Addendum #1 to Update #2 to the
Technical Drainage Study for

Grand Canyon Village
Las Vegas, Nevada

**SUBJECT: ADDENDUM #1 TO UPDATE #2 TO THE TECHNICAL DRAINAGE STUDY FOR
GRAND CANYON VILLAGE (DS #5398)**

**CLV COMMENT LETTER FOR GRAND
CANYON VILLAGE UPDATE #2
(DS#5398D)**

STORM DRAIN LATERAL 3
(PUBLIC)

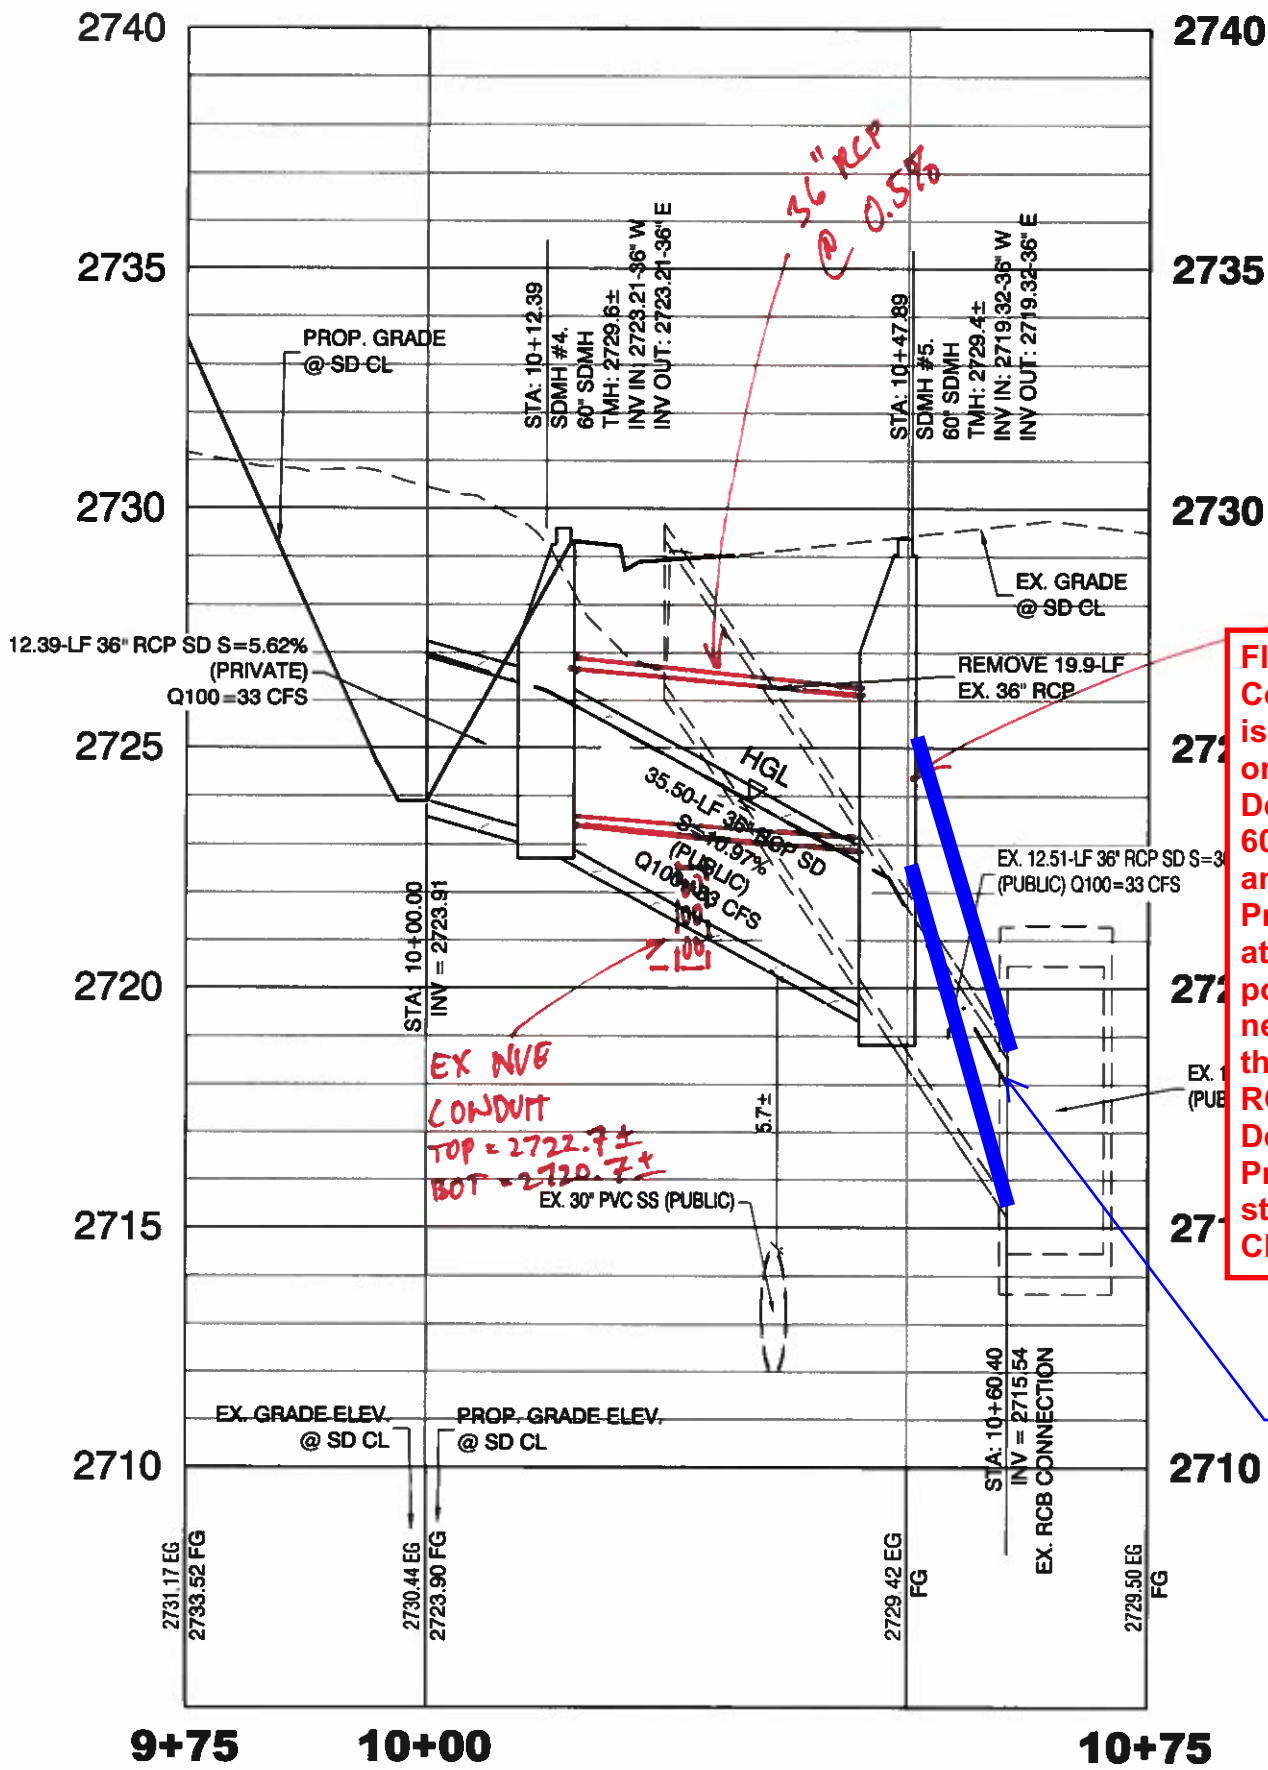
Flood Control - PBJ, 6/2/22
Concept of no Drop Manhole is much better. No Structural on the manhole, reference the Detail being used. 60" manhole with 30" cover and steps to the invert. Provide concrete collar Detail at the new pipe penetration point into the RCB. You might need your Structural to look at the Connection detail to the RCB. Email over proposed Detail for approval. Provide new pipe slopes. On steeper RCP connections use CLSM backfill.

if existing pipe is removed to the box and new pipe is reconnected. are structurals calcs needed? can a collar detail be added?

SHEET SD2

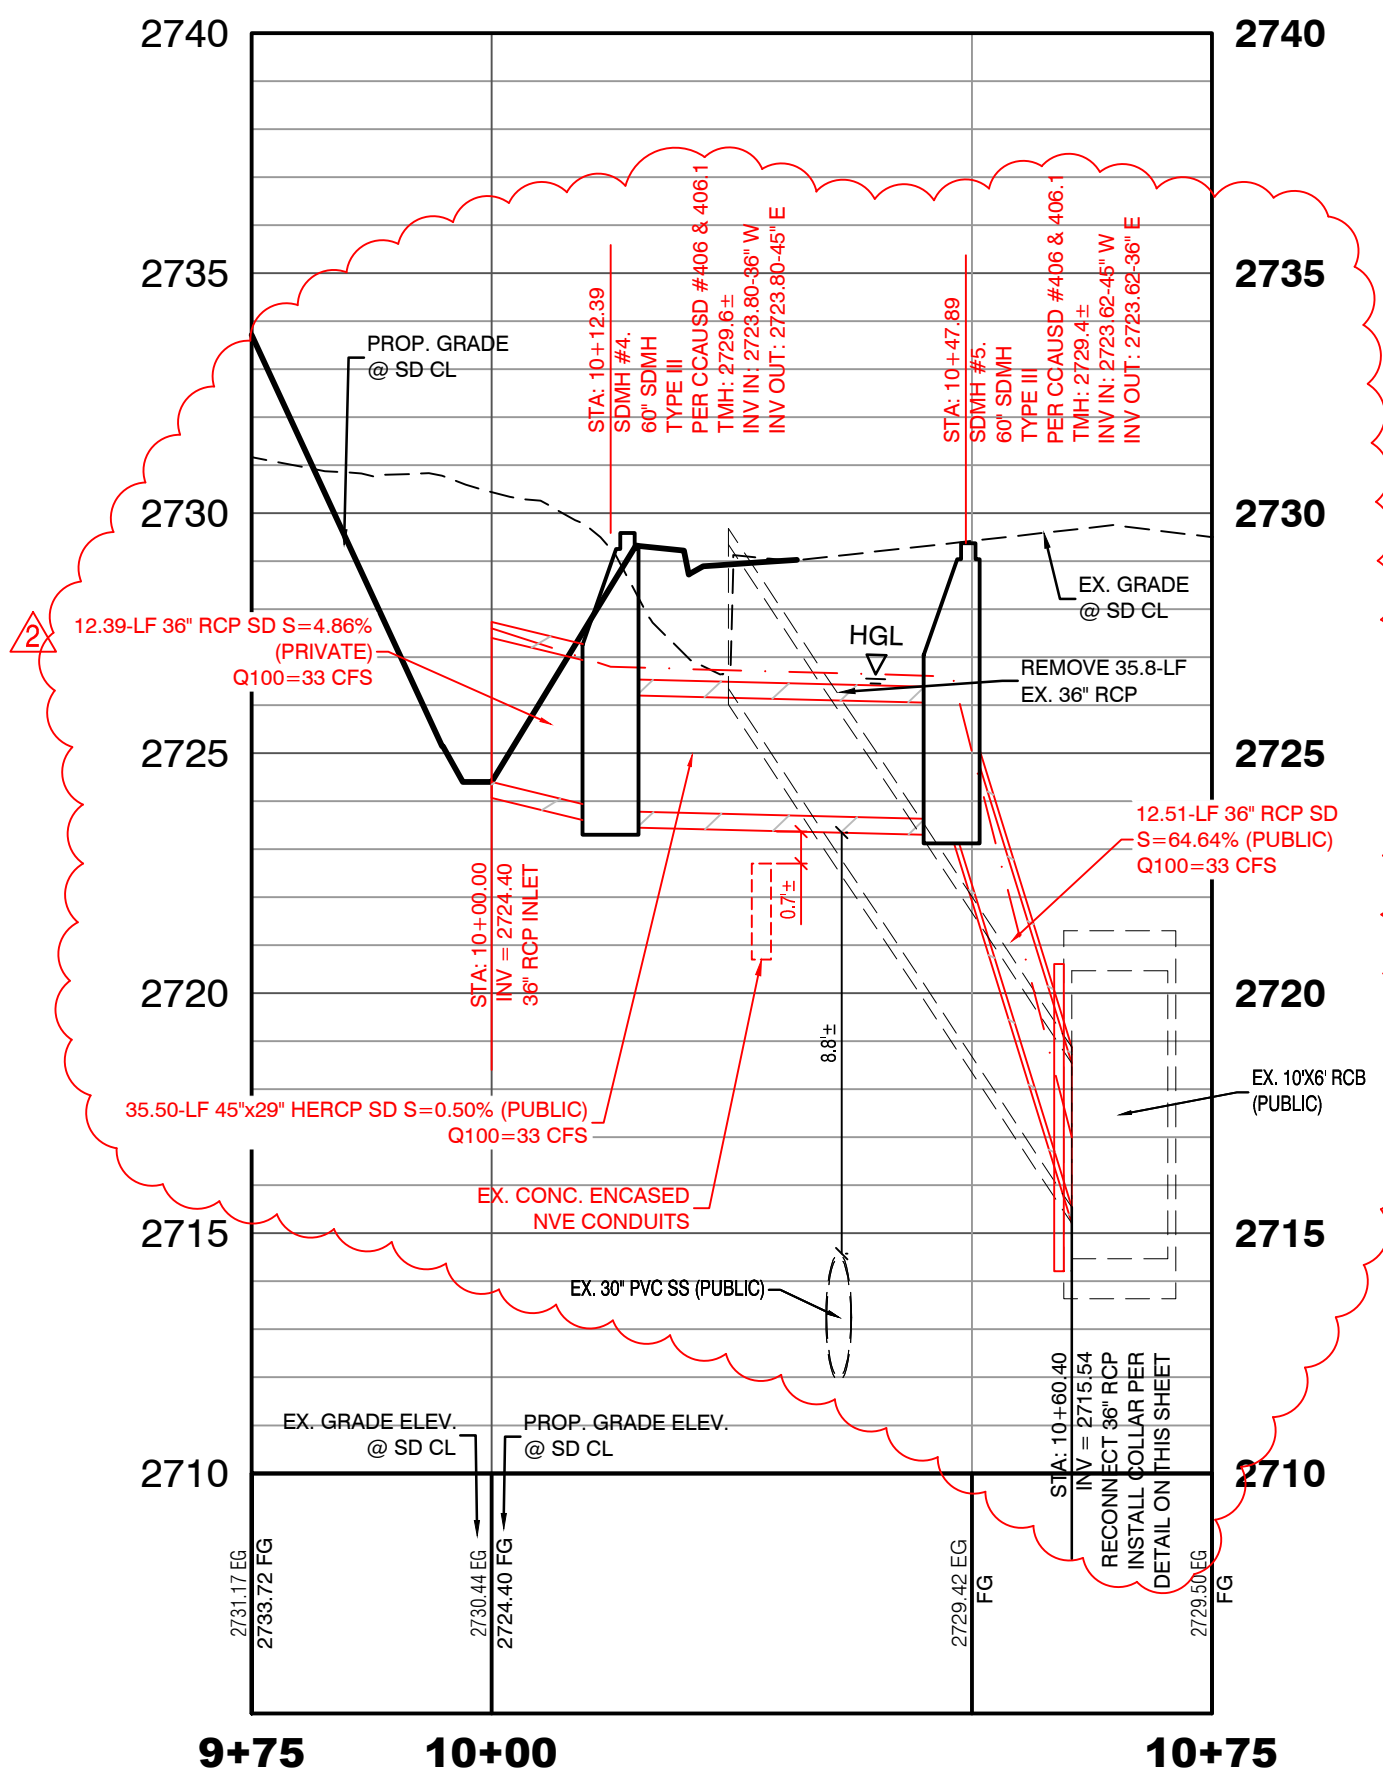
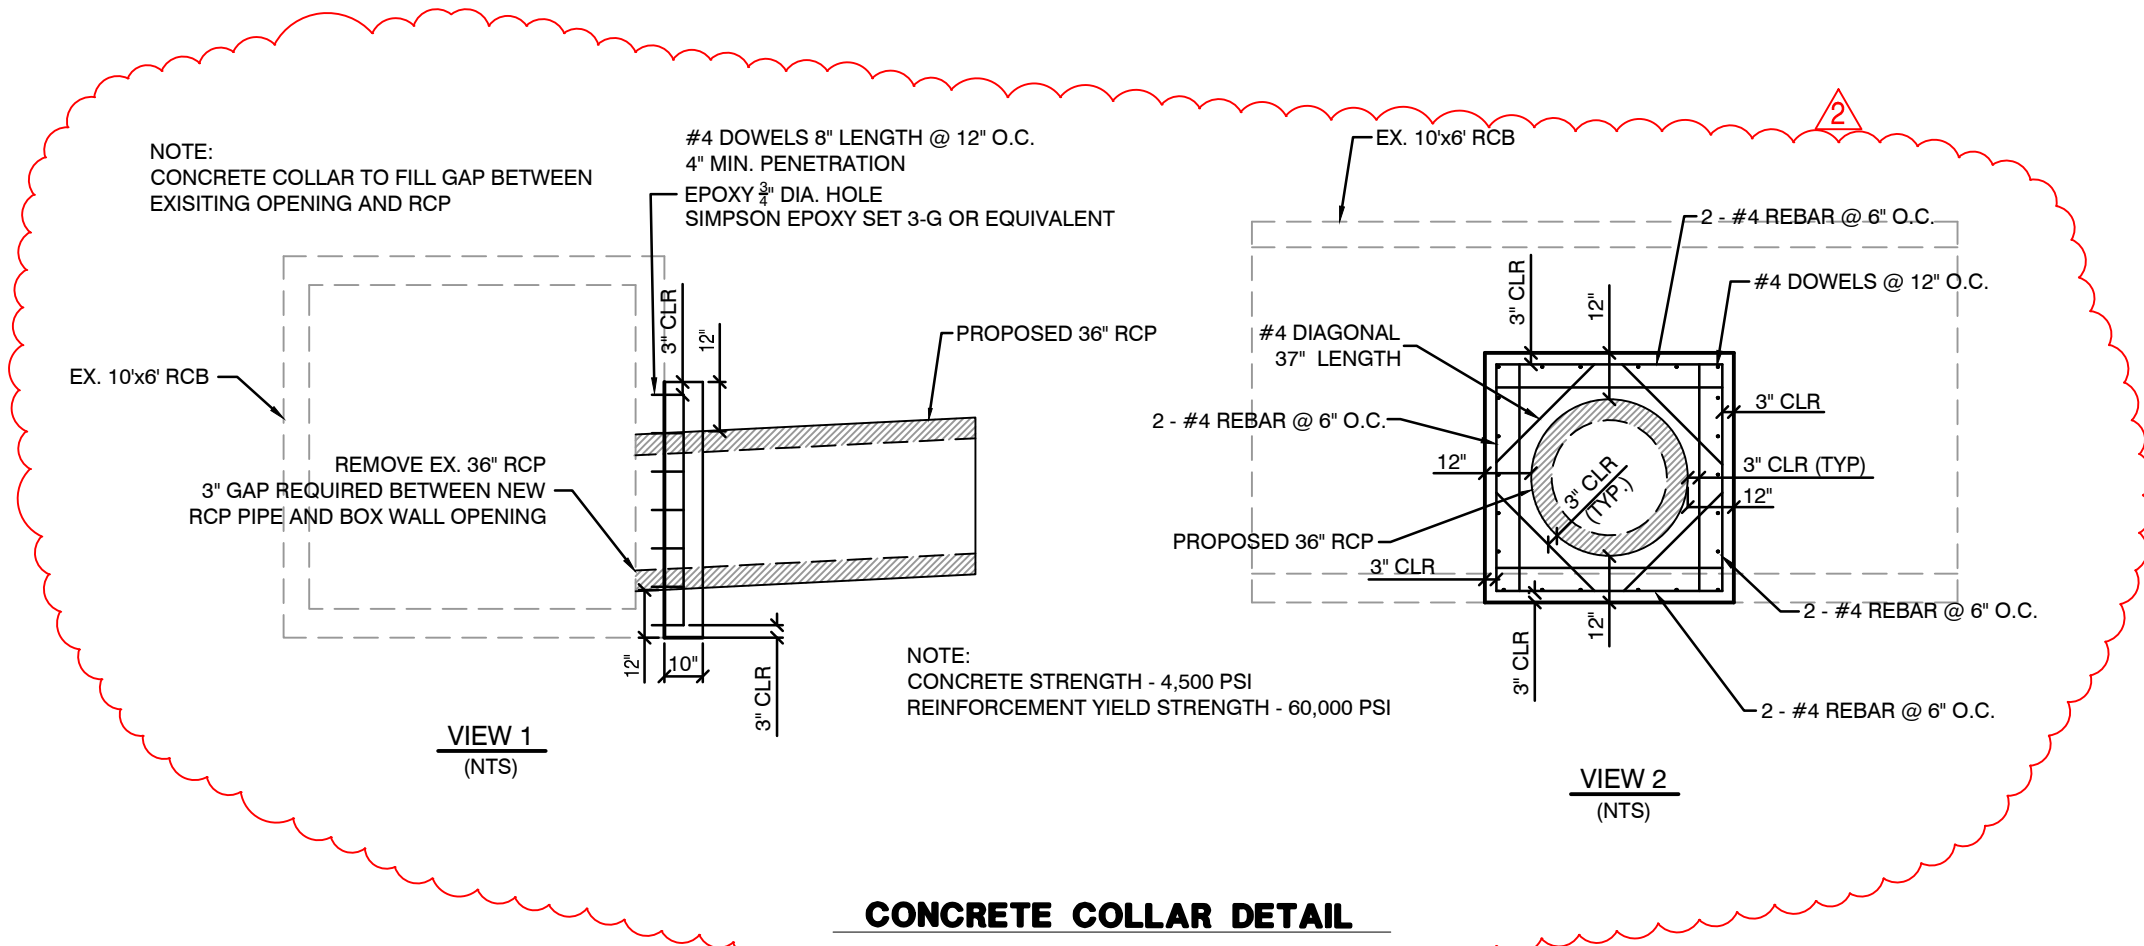
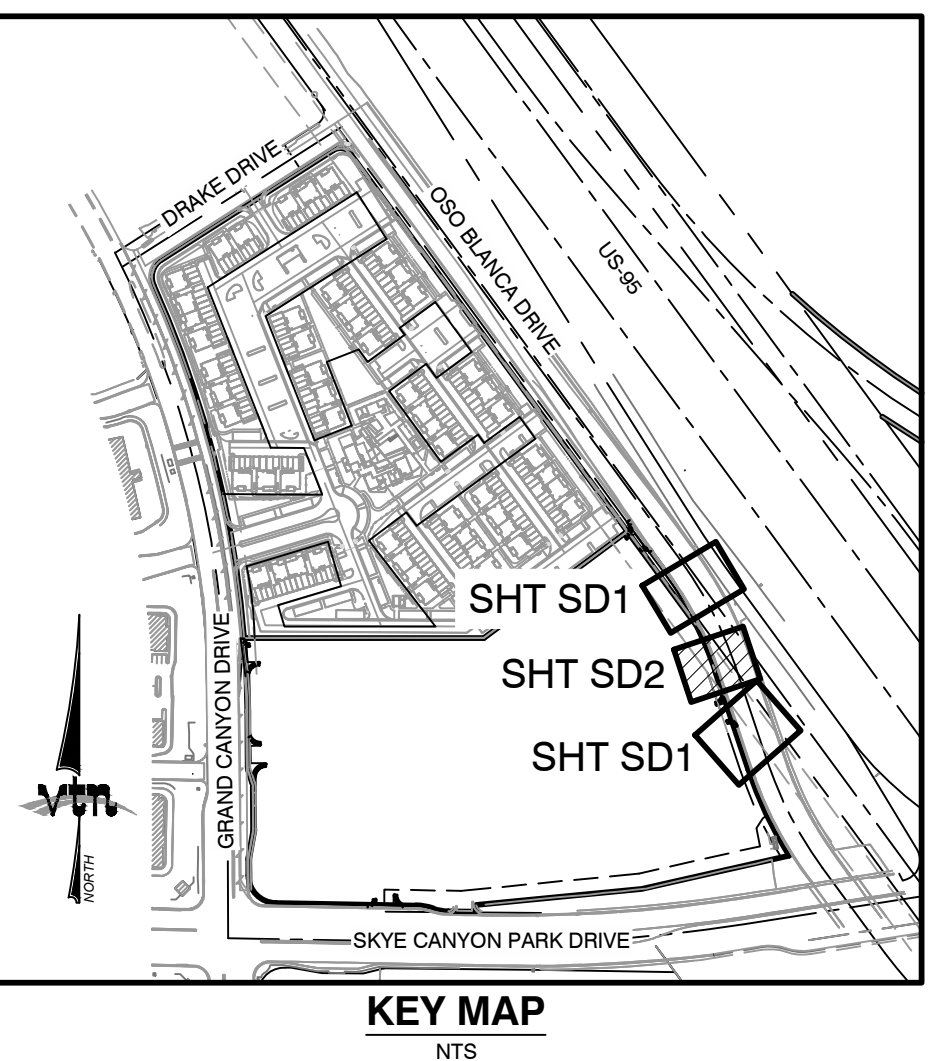
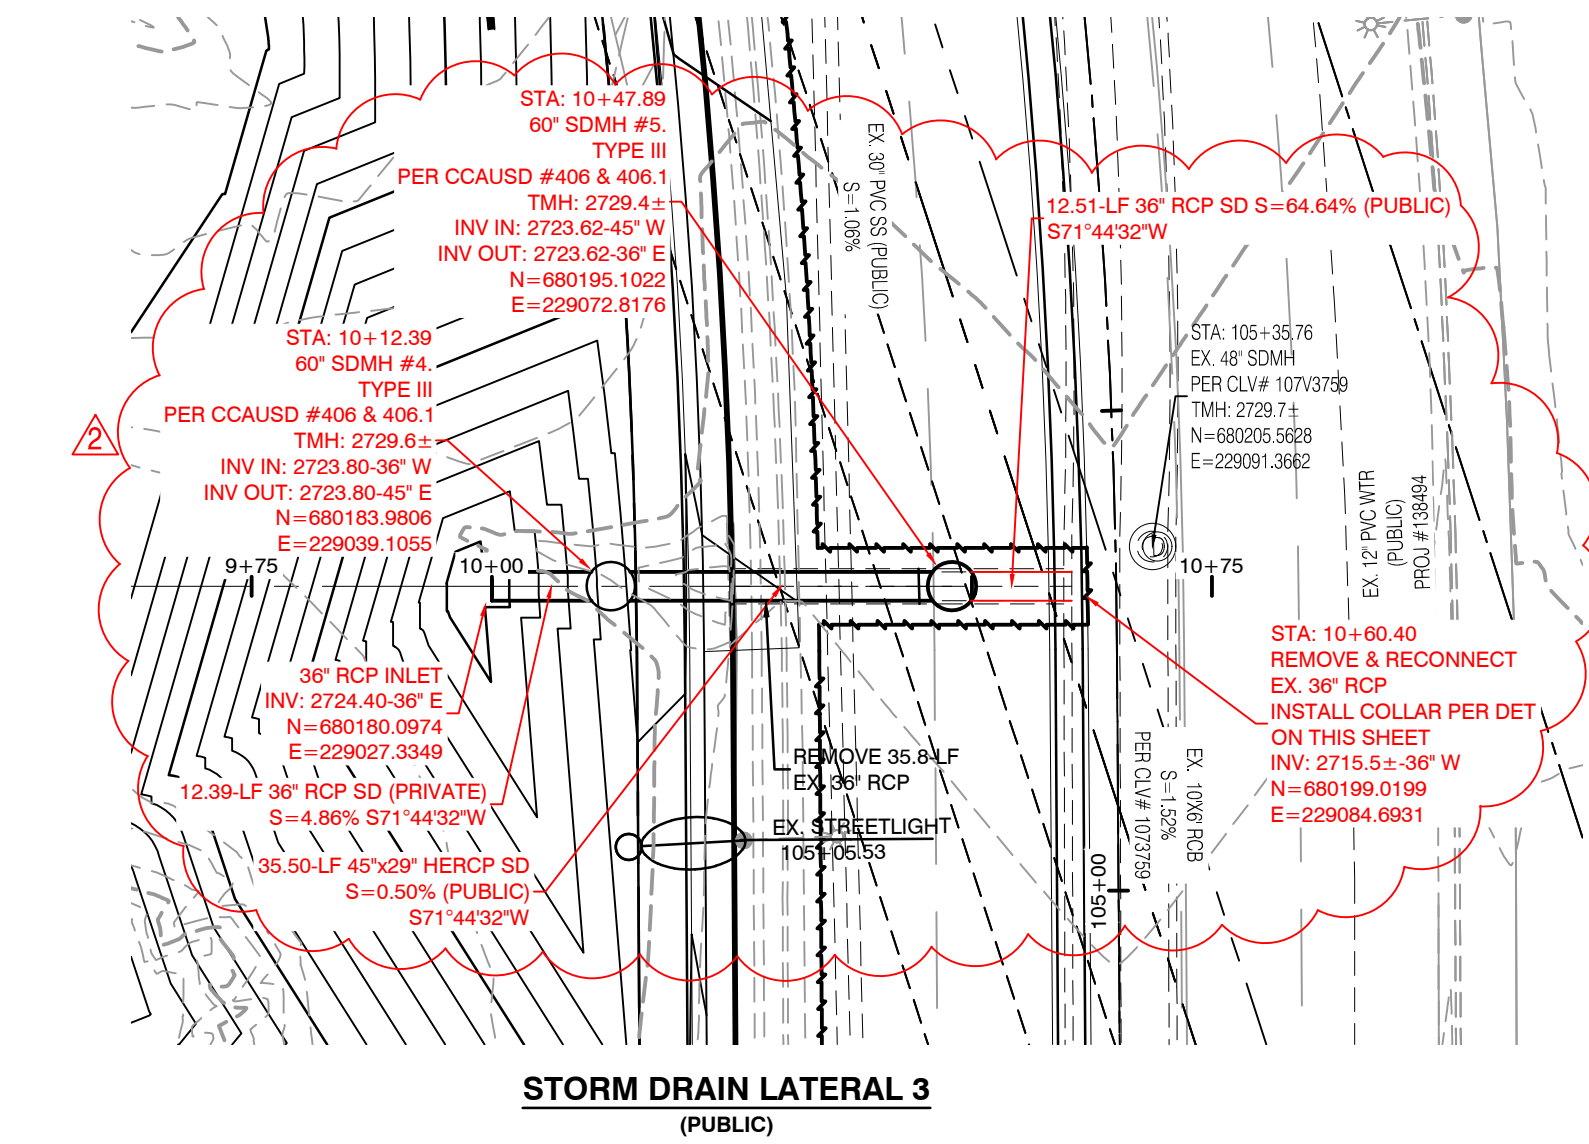
Sheet SD2: Drop manhole (SDMH #5) is not acceptable. It appears that the reason of proposing a drop manhole is to clear an existing NVE conduit. The engineer may consider adding another storm drain manhole passing the conduit and another pipe to connect to the bottom of SDMH #5. Specify clearly the SDMH to be Type II Manhole per USD 405.1. Address and revise in the next submittal.

- Sheet SD2:** Drop manhole (SDMH #5) is not acceptable. It appears that the reason of proposing a drop manhole is to clear an existing NVE conduit. The engineer may consider adding another storm drain manhole passing the conduit and another pipe to connect to the bottom of SDMH #5. Specify clearly the SDMH to be Type II Manhole per USD 405.1. Address and revise in the next submittal.

RESPONSE: The proposed storm drain has been revised to remove the drop manhole per correspondence with CLV Public Works. Instead, the full removal of the existing 36" RCP stub to be replaced with a connection of 36" RCP ± 12.51 -lf long at $\pm 64.64\%$ slope is now proposed with the connection detail shown on sheet SD2. Additionally, 35.50-lf of 29"x45" HERCP has been proposed between SDMH#4 and SDMH#5, replacing the previously proposed 36" RCP for clearance purposes. Consequently, Type III Manholes are now proposed to accommodate the increased width. A markup and relevant e-mail correspondence with comment from CLV public works showing the proposed storm drain changes has been provided in *Appendix B*.

The adjustment to the storm drain facilities resulted in the revision of Standard Form 6 hydraulic calculations to show that the HGL meets criteria. The newly proposed 29"x45" HERCP has been modeled using the circular equivalent of 36". Note that this update does not propose any revisions to approved hydrology. The revised hydraulic calculations have been provided in *Appendix A*.
